April 3, 2009

**ADDENDUM NO. 1
FOR THE
HAPPY HOLLOW PARK AND ZOO PEDESTRIAN BRIDGE REBID**

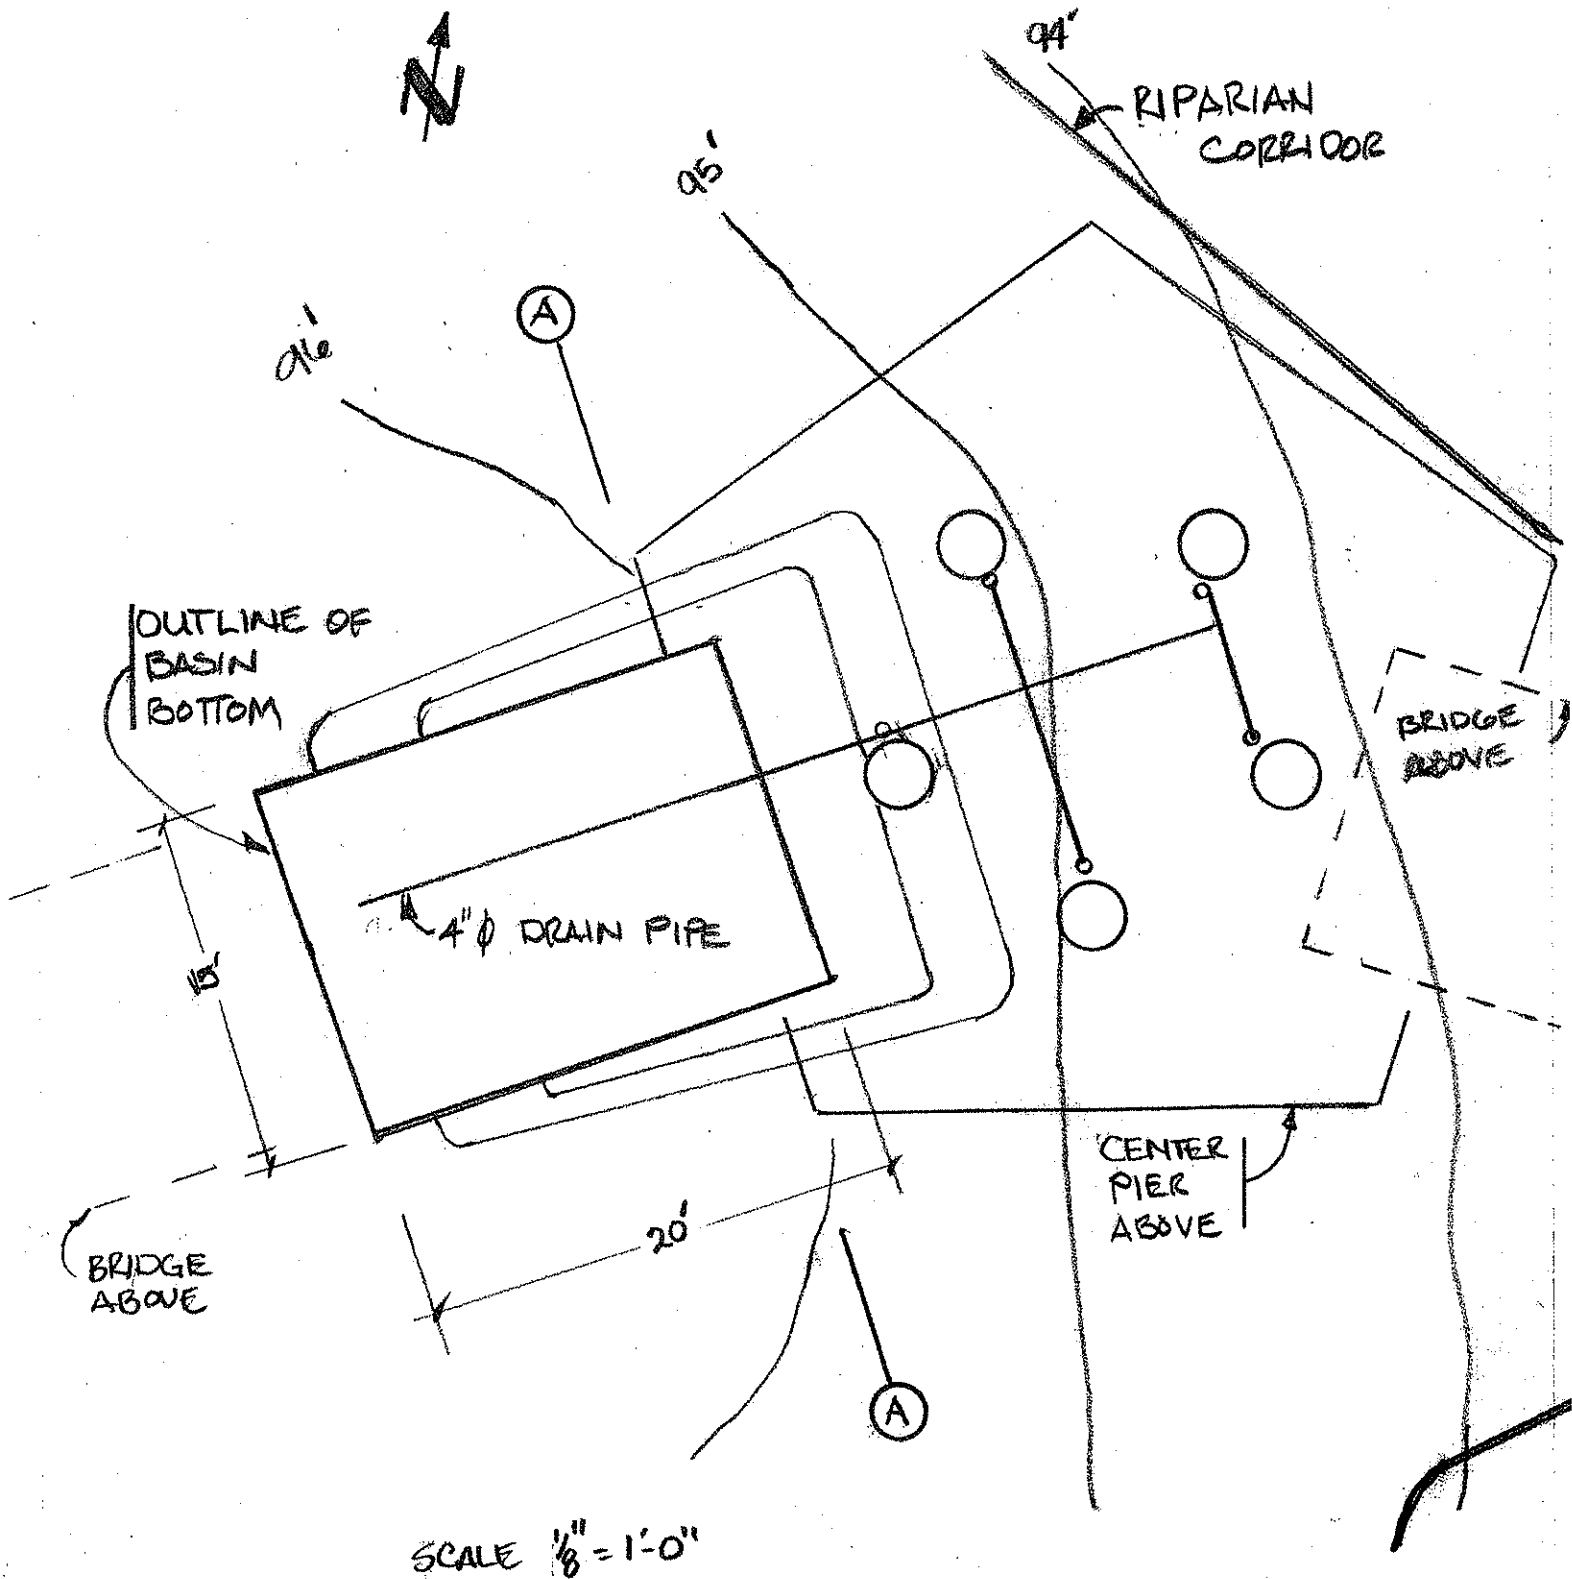
- 8. Sketch AD-1 and AD-2, entitled, "Infiltration / Retention Basin Plan View" and "Section of Infiltration / Retention Basin" respectively are added.

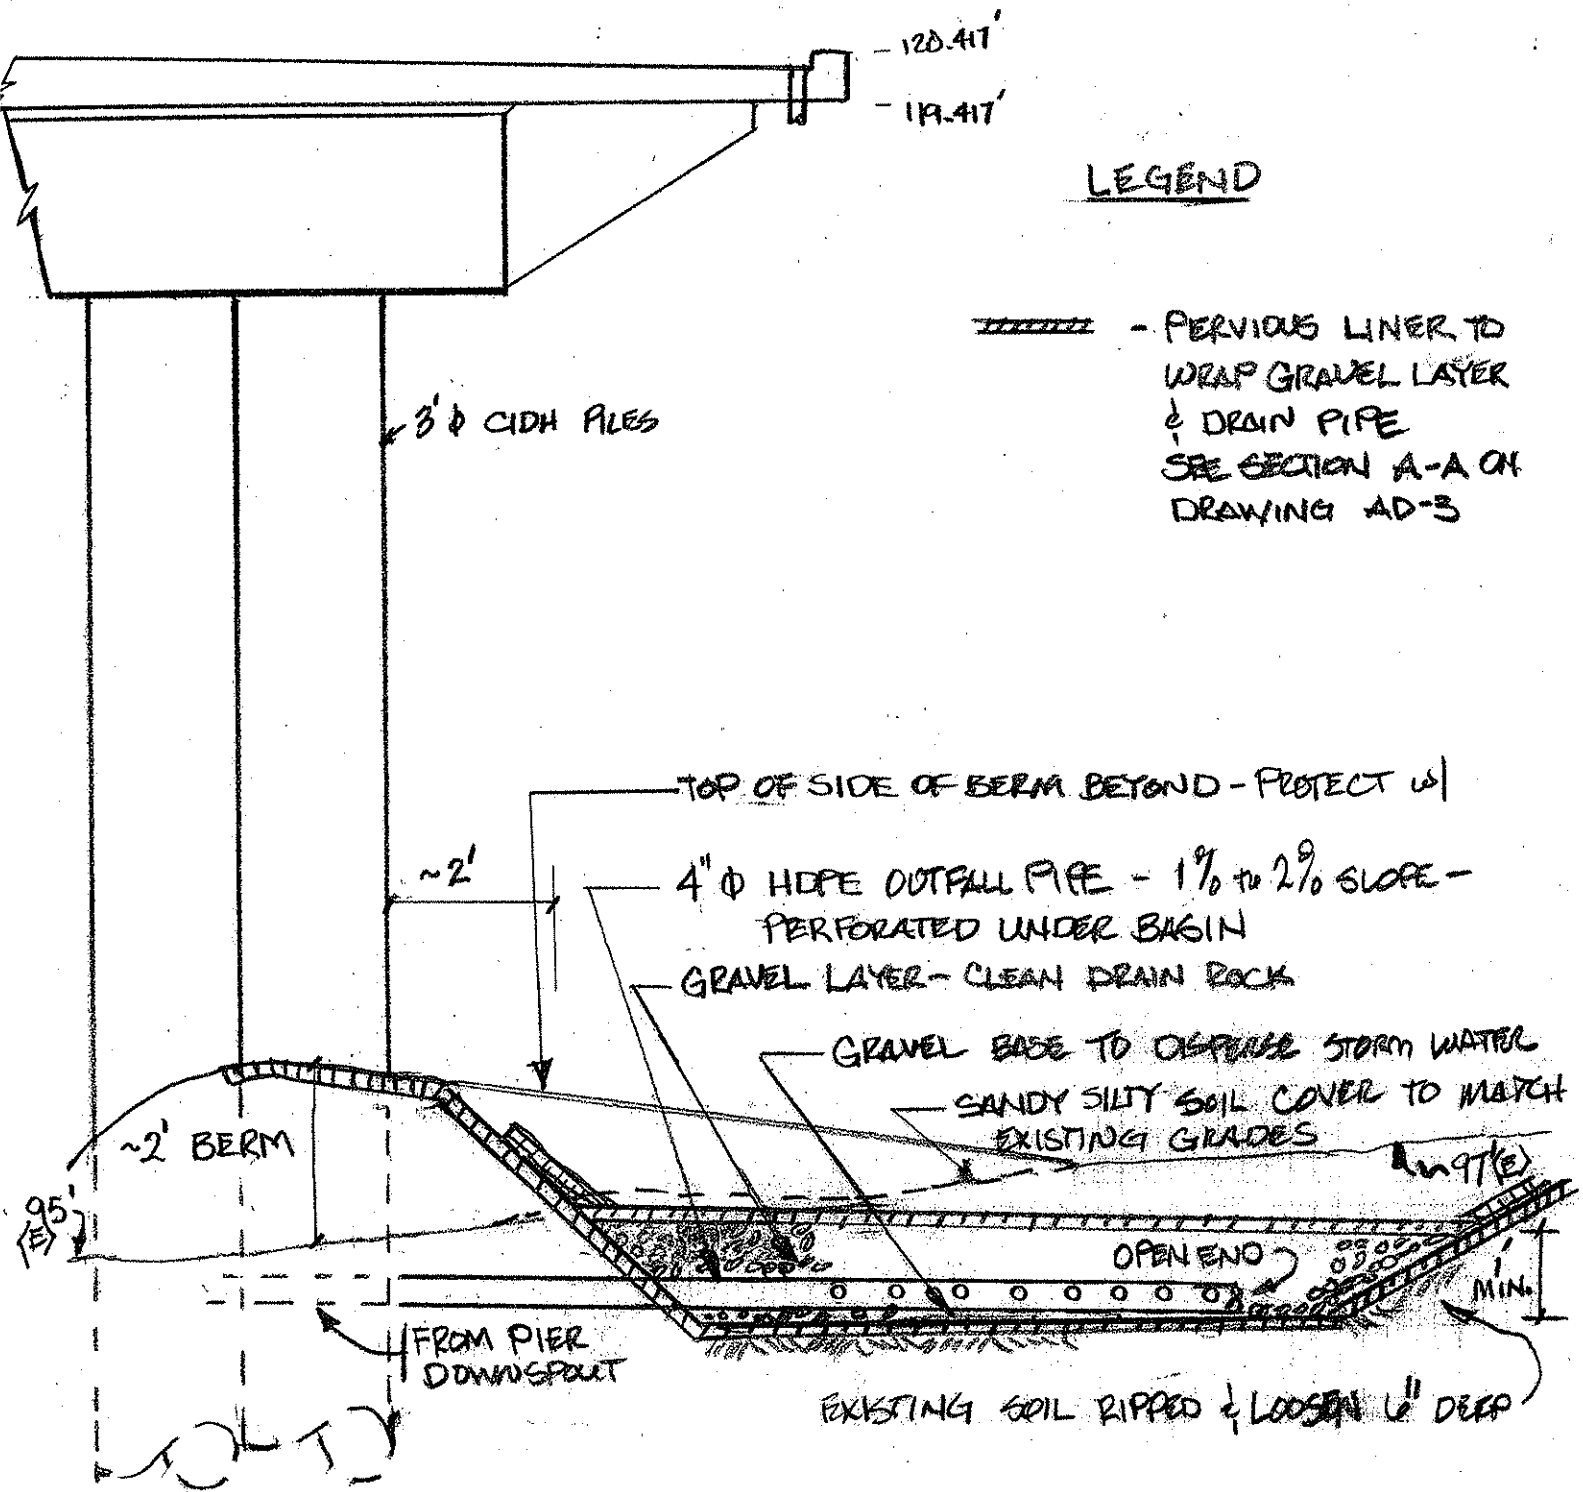
1. Contractor shall plant SOD, NO MOW or approved equal, to cover basin, berm and surrounding areas around basin and up to Riparian Corridor, unless existing lawn is still healthy.
2. Provide maintenance for new SOD, existing grasses and plants per addendum modifications to Section 02950 - SODDING.

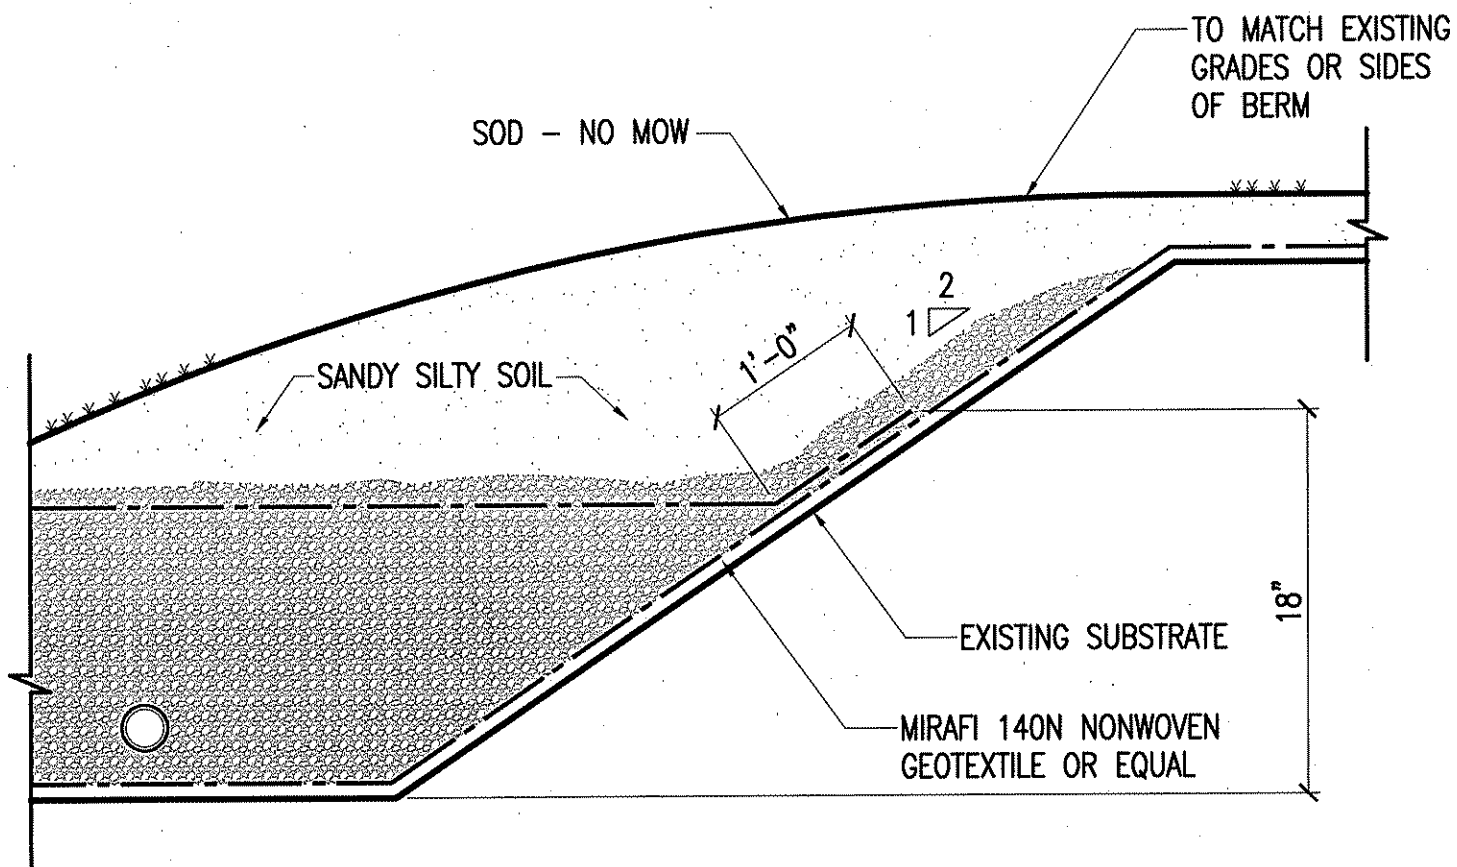
- 9. Sketch AD-3, entitled, "Detail of drainage pipe at bottom of basin".
- 10. Sheet G2:
 - a. Sheet No. S10A added to "Index of Drawings"
 - b. Sheet No. S44A added to "Index of Drawings"
